TO: City Planning Commission

FROM: Jamie Murphy, City Planner

RE: **Request of the Detroit Regional Convention Facility Authority to show a PC (Public Center) zoning district where a B5 (Major Business) zoning district is currently shown on two parcels commonly known as 560 and 580 Civic Center Drive. Additionally, a PC District review of a proposed addition to the Huntington Place Convention Center.**

DATE: April 11, 2025

Rendering of proposed addition to Huntington Place – looking northeast

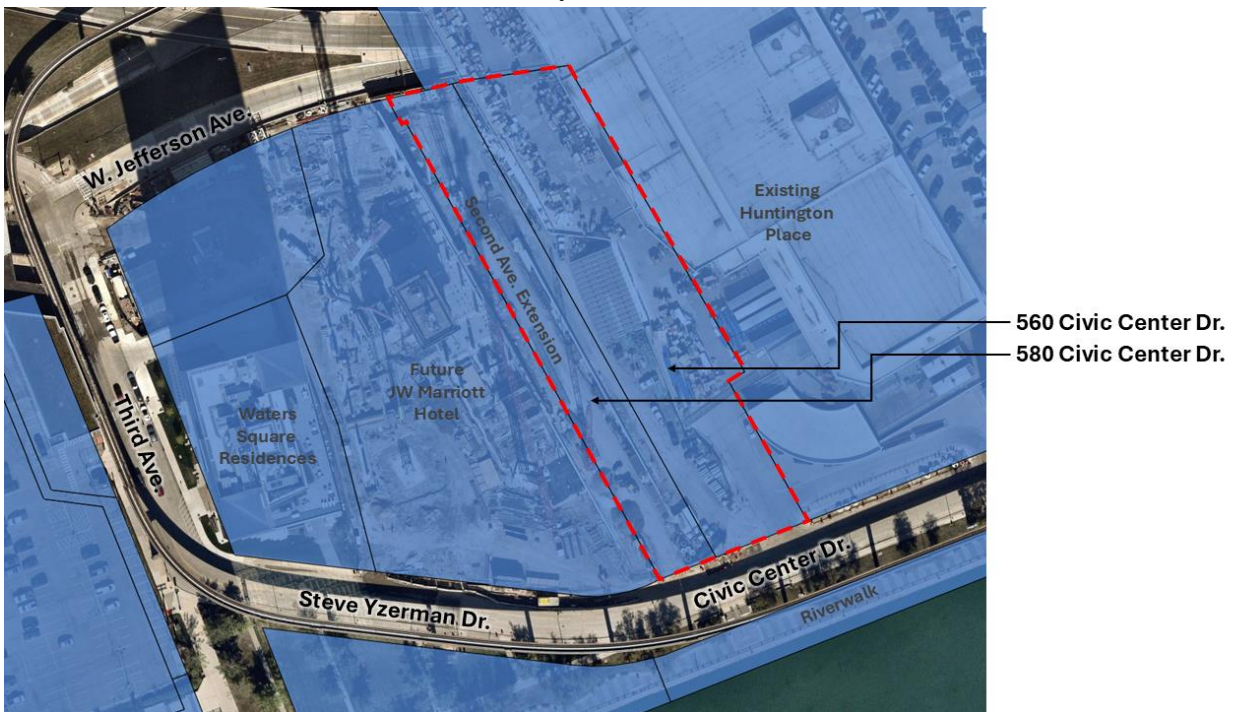
The majority of the south and west facades of the addition are proposed to be white ceramic tile panels and glass with a dramatic grille pattern. Smaller areas of metal panels in a gold/bronze color are proposed around the entryways and wood for the soffit area near the roof. The north and east facades, which face the existing convention center, will be clad in dark gray metal panels and white EIFS (exterior insulation and finish system).
